Product Change Notification: E-20-014128

CAP 90 DEG & 180 DEG FOR CORRUGATED TUBES NW 8.5 & NW10

Product Material Change to PA6 DIN CAP 90° and 180° Versions

PN 965576-1, 965783-1, 965784-1 and 965786-1

965576-1 (COVER 90DEG) REV-C

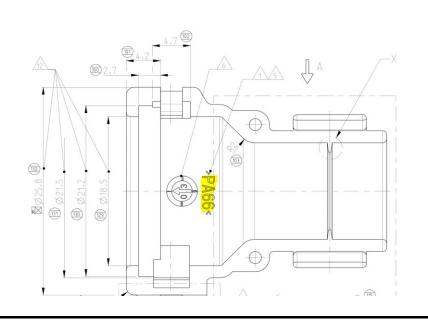
Major Change: Product Material Change to PA6 DIN CAP 90 DEG & 180 DEG. See Attachment For More Details.

The decision to replace the current PA66 resin material with a PA6 is due to our previously experienced and expectations of future volatility with market conditions using PA66. Our proactive effort began as a business decision to ensure good material availability at our facilities across EMEA and to mitigate any potential unexpected volatility with cost increases from present levels in PA66 pricing from later increasing market demands.

"REPLACED CURRENT PA66 RESIN MATERIAL WITH PA6 TO IMPROVE PRODUCT"
